PETNET Solutions

March 29, 2013

Re: PETNET St. Louis Effluent Control and Monitoring Issue for Radioactive Materials License No. 41-32720-03

**Attachment C
Effluent Diagram**

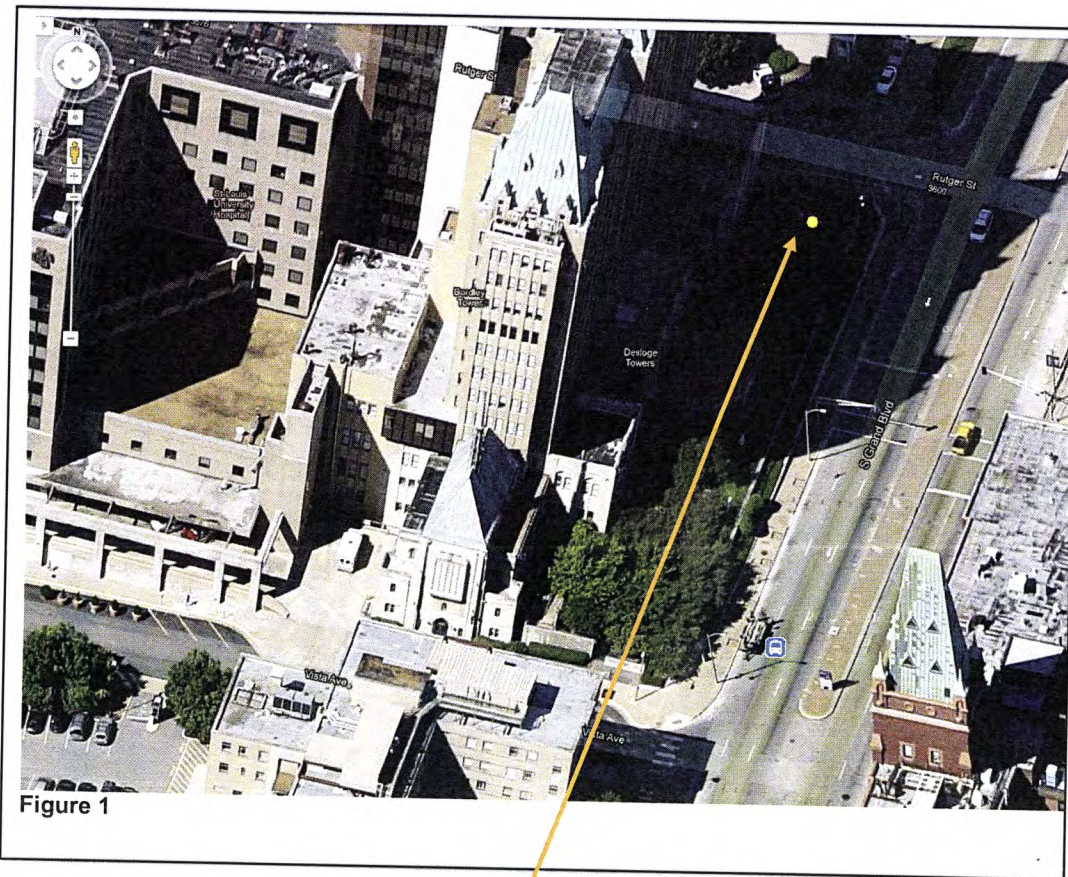
9. *Regarding the section on page 22 entitled, "Effluent Control & Monitoring": Provide a description and diagram of the point of release of effluent from the cyclotron/pharmacy operations. Please also describe the point of release relative to the nearest air intake of the SLU hospital, entrance and exits to the hospital, and the nearest unrestricted areas.*

Figure 1

Stack discharge point

Figure 2

Upper patio area

Stack discharge point

Figure 1 – Yellow circle denotes effluent release point, red box denotes deck area

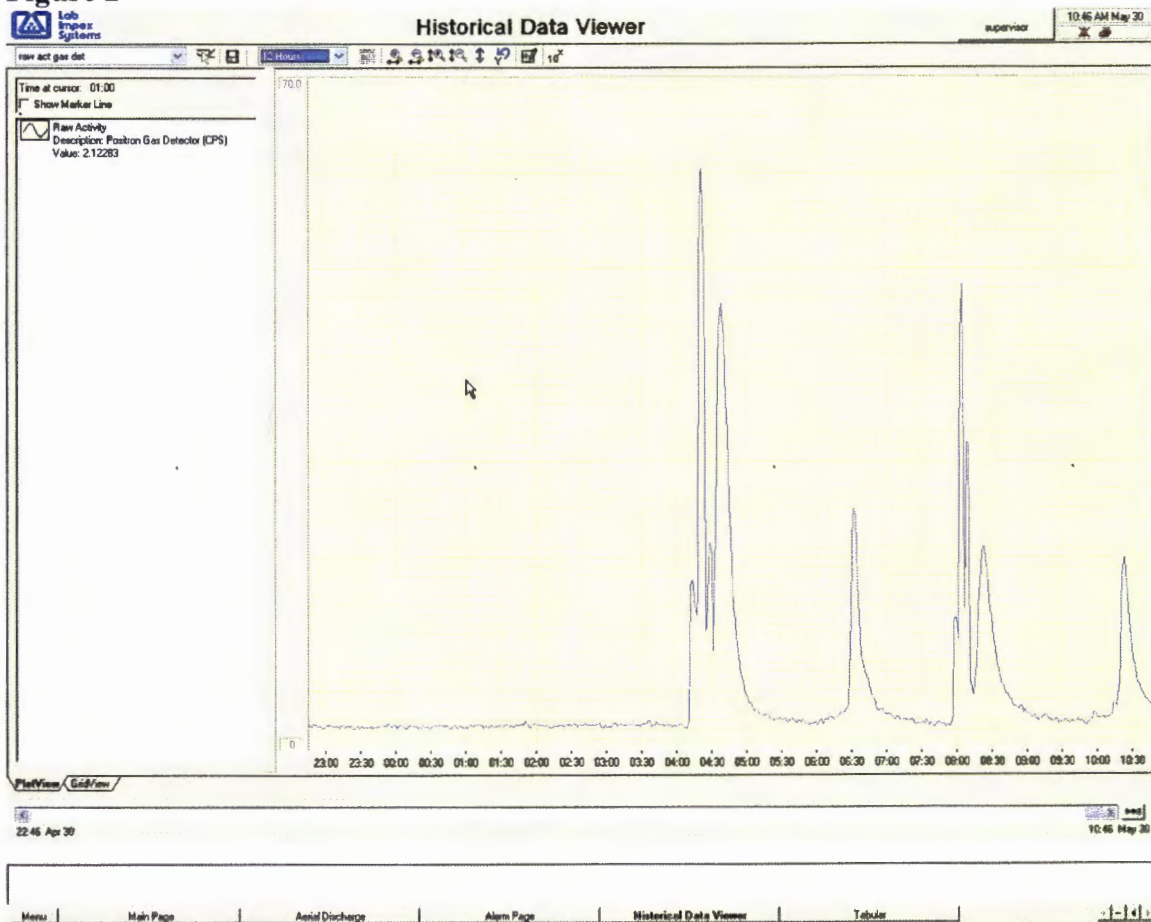
As a result of NRC concerns about public dose from effluents, use of the deck area is prohibited. The Hospital has requested unrestricted access to the deck area located in the garden (see Figure 1). An emergency egress route through the garden is required per life-safety code, but does not impact compliance with public dose limits. The purpose of this study was to examine the concentration of radioactive materials on the deck level and in the garden area during synthesis of PET radiopharmaceuticals.
